BANKSTONE PRESERVE
A RESIDENTIAL DEVELOPMENT

REZONING SITE PLAN

PETITION NO: Z-15

PLANNING COMMENTS:

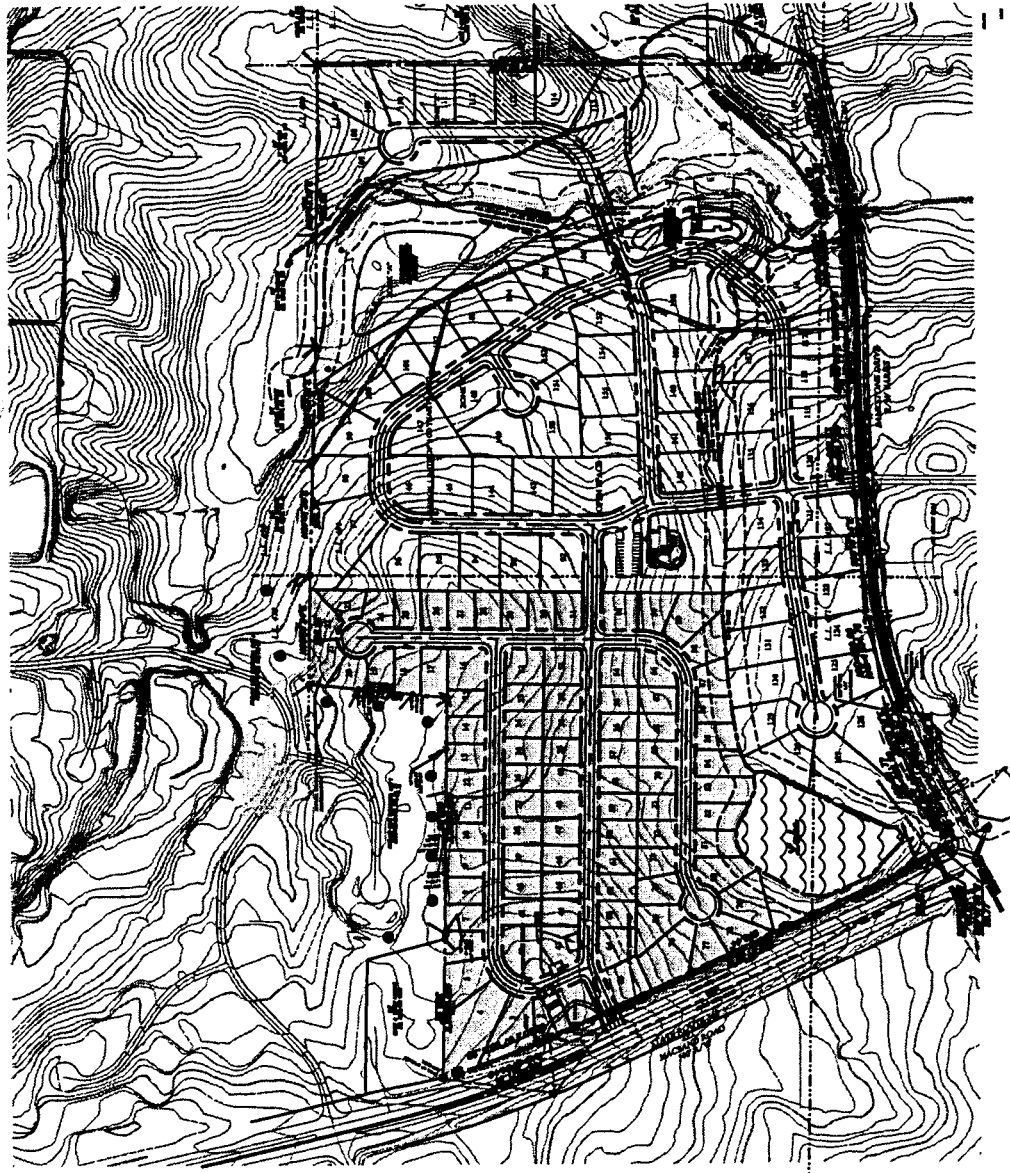
The applicant is showing two contemporaneous variances on the site plan which are:

1. Reduce the rear setbacks on the RA-5 portion, from 30-feet (interior lots) and 40-feet (exterior lots) to 20-feet.
2. Reduce the number of parking spaces in the amenity area from 26 parking spaces to 22 parking spaces.

1. The existing site is a mixture of pasture and woodland with gently rolling terrain. There is an existing lake located at the northwest corner of the site and a significant amount of floodplain associated with an unnamed tributary to Noses Creek along the southern portion of the site. Although the data provided on the site plan states that there is only 3.11 acres of floodplain, the County's GIS mapping reflects a total of 11.3 acres of FEMA Zone A Floodplain as well as 2.9 acres associated with the flood pool of the existing lake. This should be correctly reflected in the density calculations.

2. All of the proposed stormwater management facilities must be located above (outside) the 100-year floodplain. This will require a revision to the site plan to provide adequate site area to relocate the large easternmost detention pond.

3. A detailed flood study will be required to determine actual 100-year flood elevations for the site. A LOMA submittal to FEMA will be required prior to permitting. Backwater effects from the proposed stream crossing must not extend upstream of the site.

4. The 50-foot stream buffer needs to be placed in Open Space outside the boundaries of proposed lots to provide protection from disturbance. Lots 79-89 and 127-142 are severely impacted by the buffer limits and will be difficult and in some cases impossible to build without disturbing this natural buffer. The site must be revised to provide sufficient protection for the stream buffer.

Align the proposed entrance on Bankstone Drive with the opposing street.
